From: [Dave Aube](#)
To: [Webb, Robert L.](#)
Cc: [Shannon VanDusen](#); [Emily Brudenell](#)
Subject: Re: 1300 Britt
Date: Friday, May 26, 2023 10:41:35 AM
Attachments: [image.png](#)
[image.png](#)
[image.png](#)
[f8a72e7d-2df9-4308-9a44-95579fc7eecb.png](#)
[image.png](#)
[A201.pdf](#)

1300 Britt

I had a couple questions on the AA submittal.

SITE PLAN

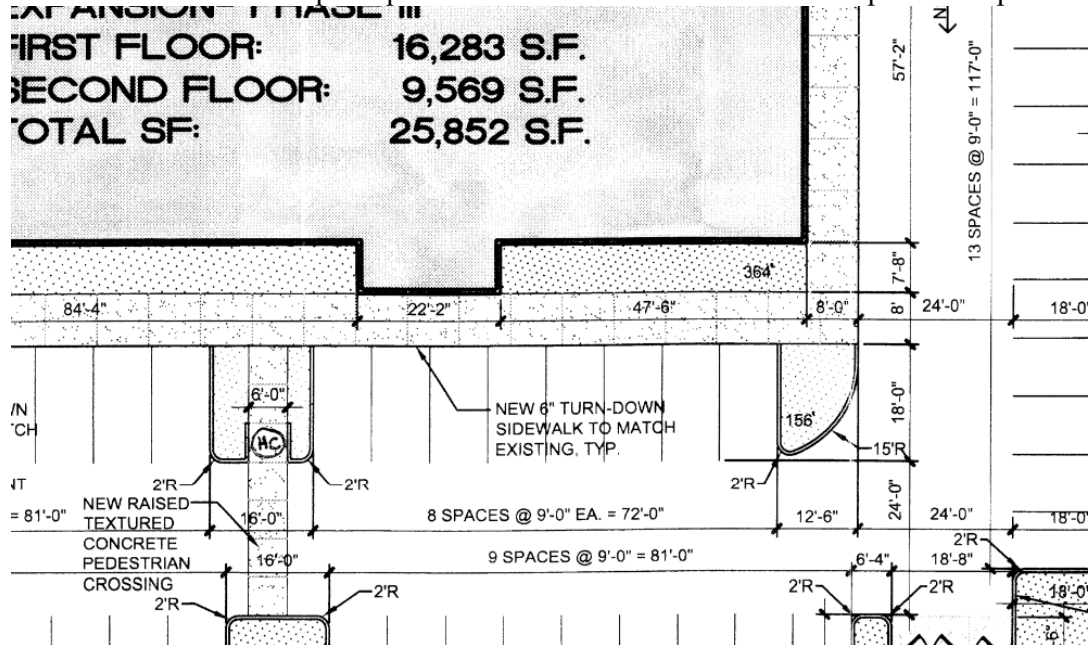
*Landscaping is being reduced.

Will it still meeting the standards of the original plan?

Or are you adding in another area?

As far as the Landscaping, we are proposing a reduction of 735 sf. We are required a total of 4011 sf, and will still have 8,435 sf on site.

Below are images from the AA we submitted that identify the required and provided totals. The image with the red revision clouds is the proposed condition. The black and white image is from the Site Plan from 2009.

As you can see the Net Lot area was slightly reduced (thus reducing the required sf). We are still well above the required and have reduced the provided landscaping by less than 10% (actually 8.2%).

LANDSCAPING AREA
REDUCTED BY PROJECT
BY 752 SF
